RE: 180-200 Warren Avenue, Morin Commercial Building
CBL: ID #2005-0275, CBL #295-G-006

MORIN COMMERCIAL BUILDING MINOR SITE PLAN APPROVAL EXTENSION

Project Name: Warren Avenue – 180-200; Morin Commercial Building; Stephen Morin
Project ID: 09-79900014 (City's reference)
Project: 180-200 Warren Avenue
Planner: Shukria Wiar/ Barbara Barhydt

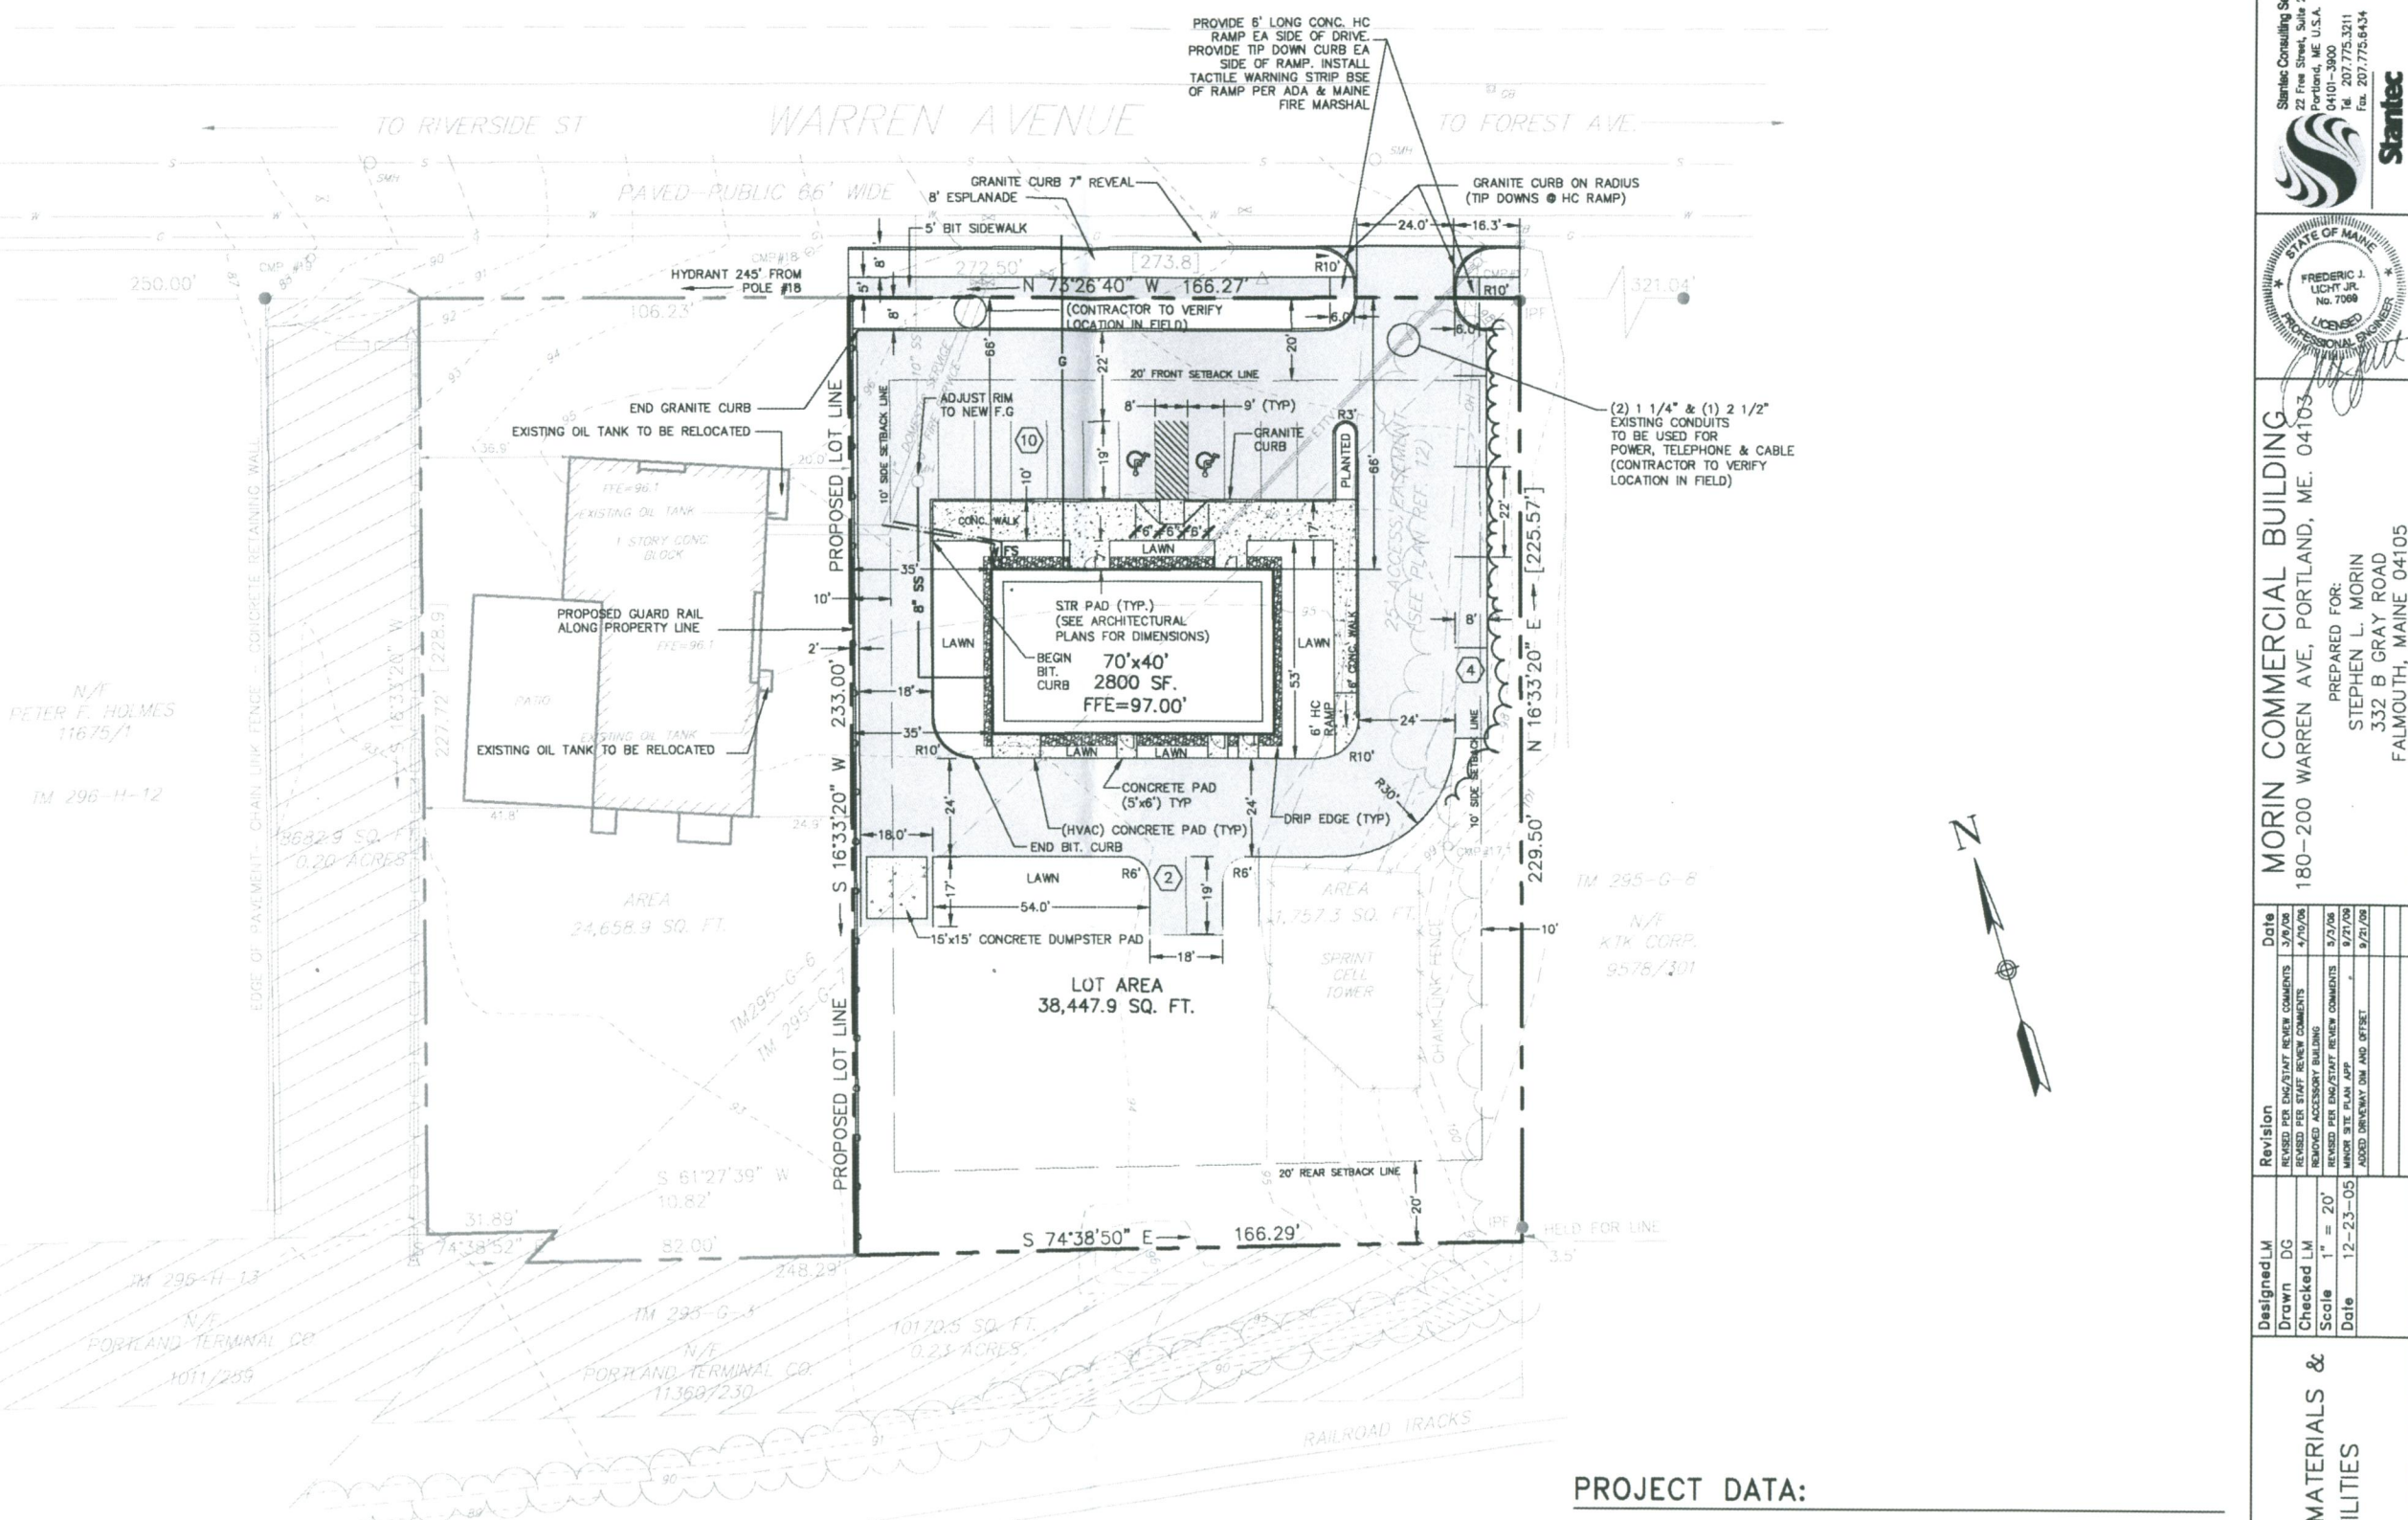
Drawing C-2, Layout, Materials and Utility Plan now shows that 4,391 SF of the adjacent lot will need to be pervious for that lot to meet the 80% max. impervious area standard. The plan calls for that pervious area to be loamed and seeded.

Recommendations would include: to extend bituminous paving around the proposed building (it is shown to end near the back left corner on sheet C-2) the additional curbing is to protect lawn & landscape areas from vehicles. 'Cape Cod' style curbing is usually preferred.

GRADING, DRAINAGE,
 EROSION CONTROLS
 & LANDSCAPING

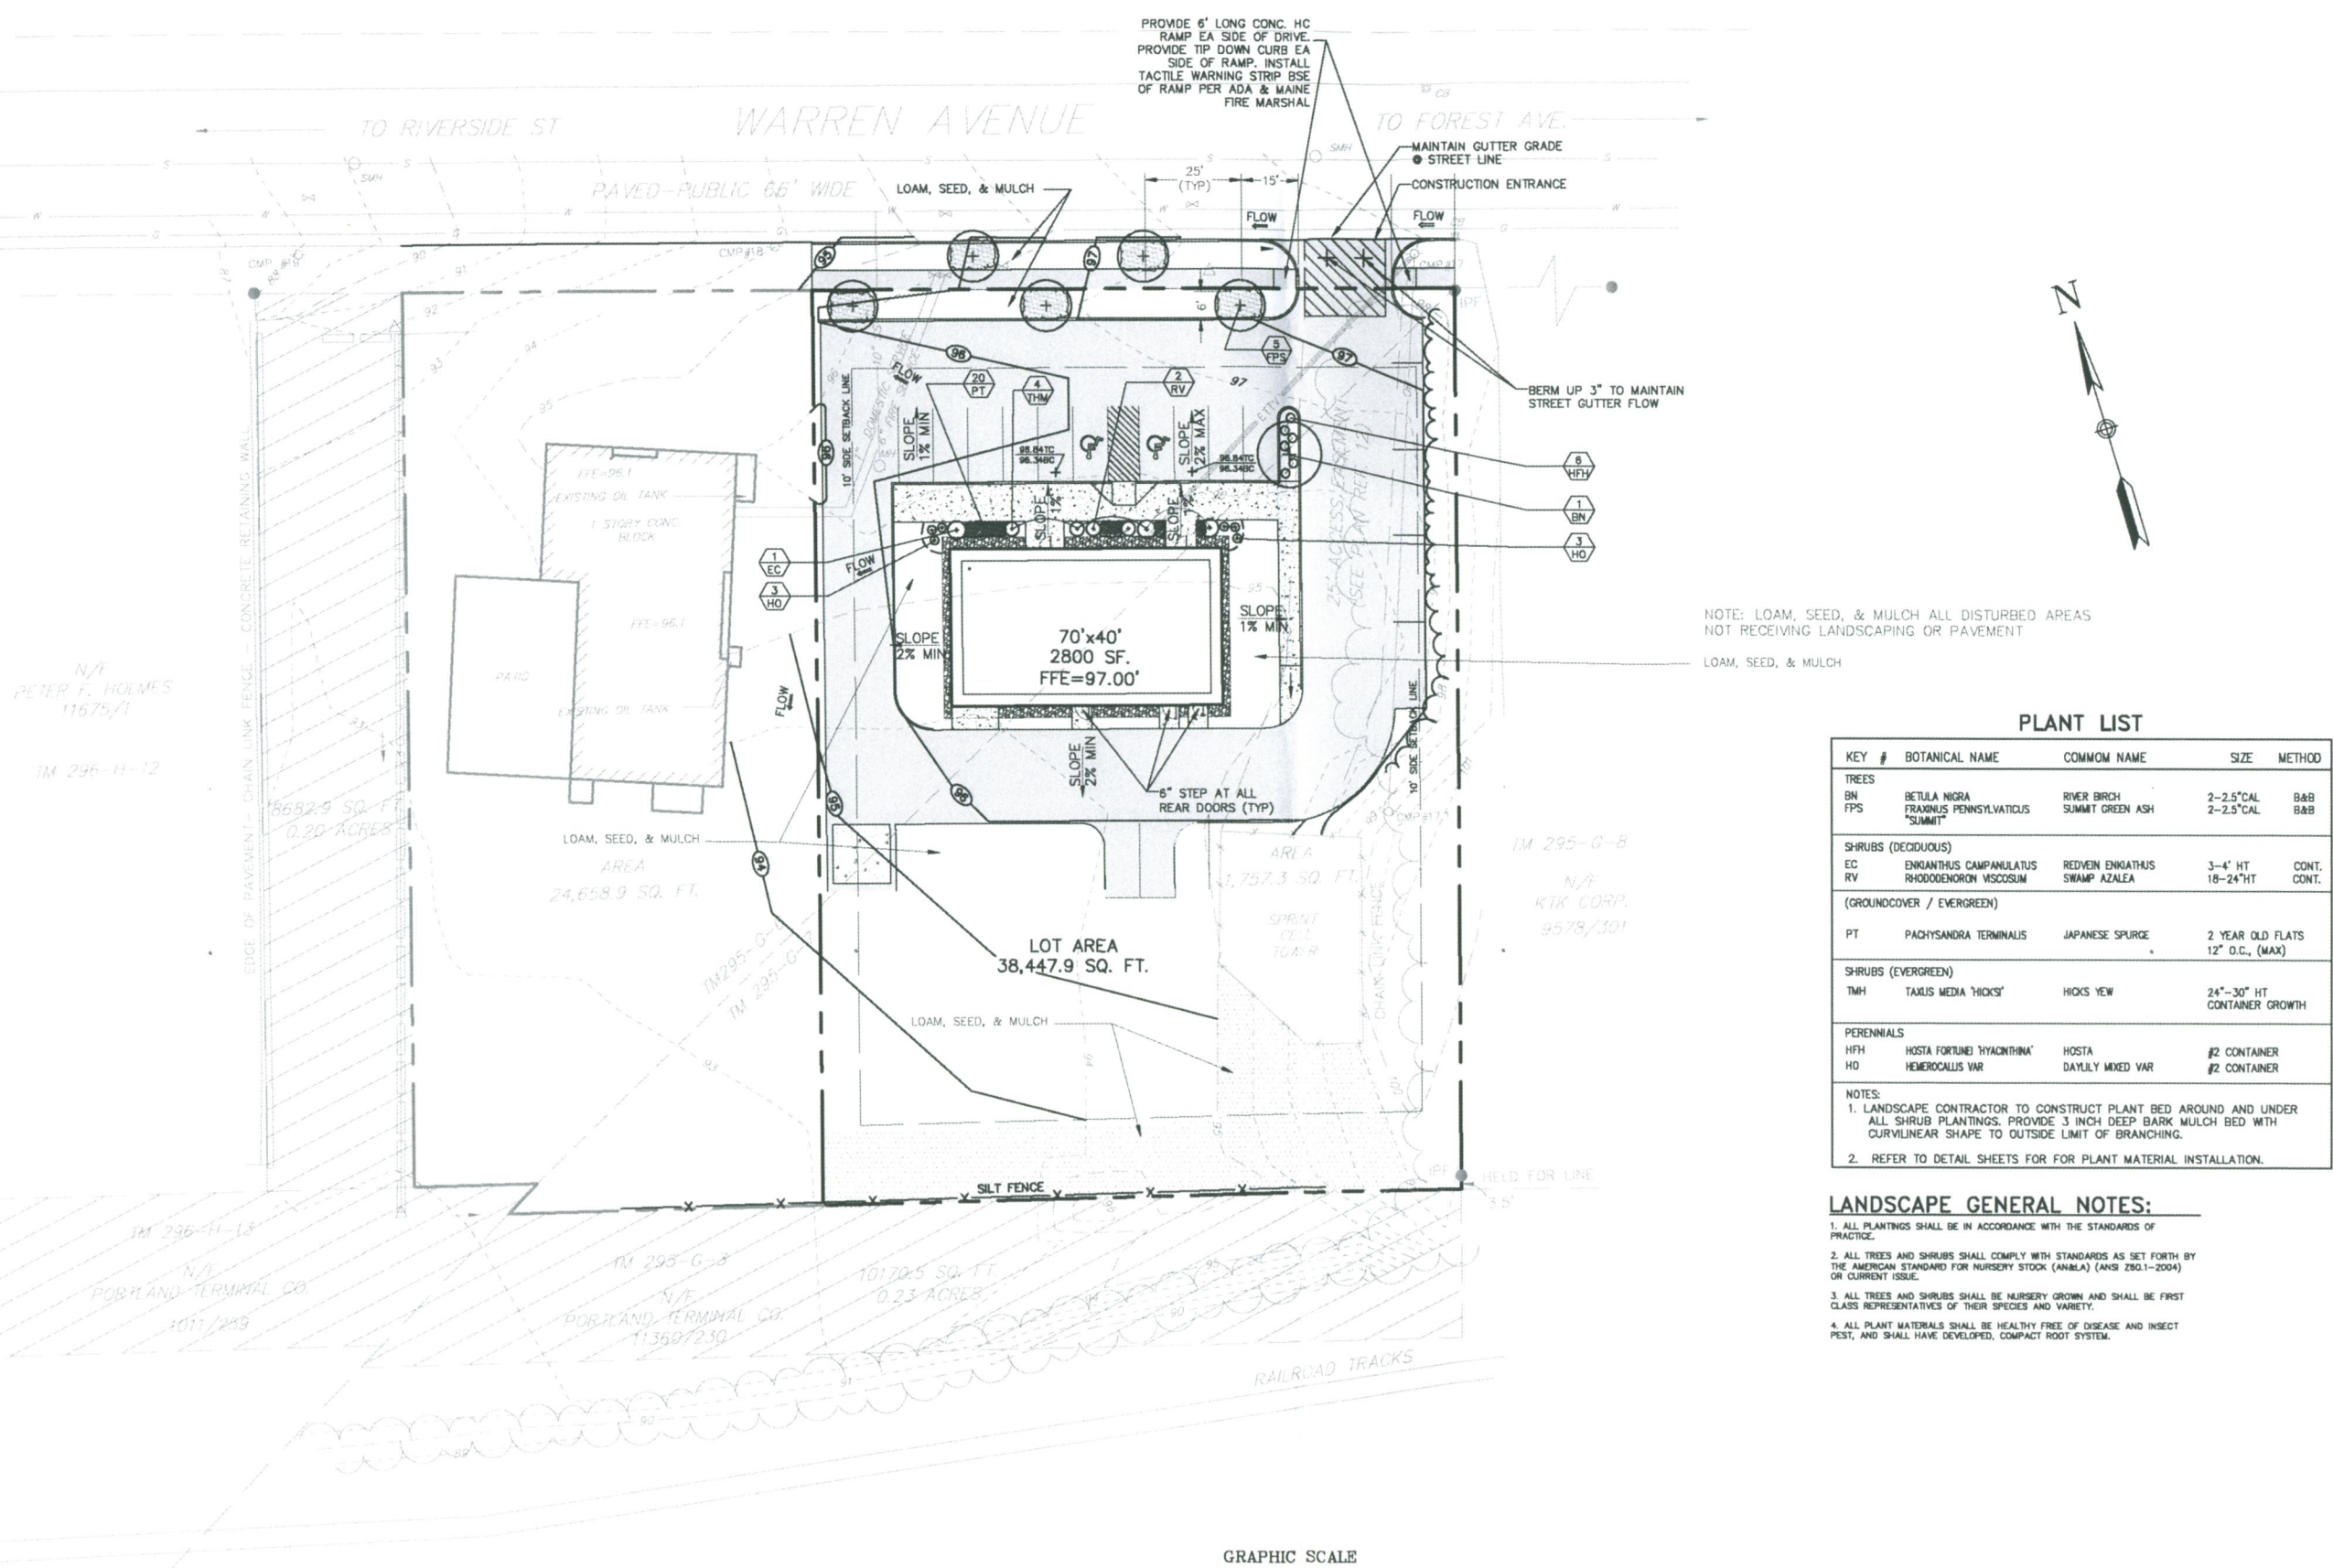
1. The landscape plan for the Morin Commercial Building as shown on plan sheet C-3 shows 5 street trees along Warren Avenue, landscape planting near the building front, dumpster fence enclosure.
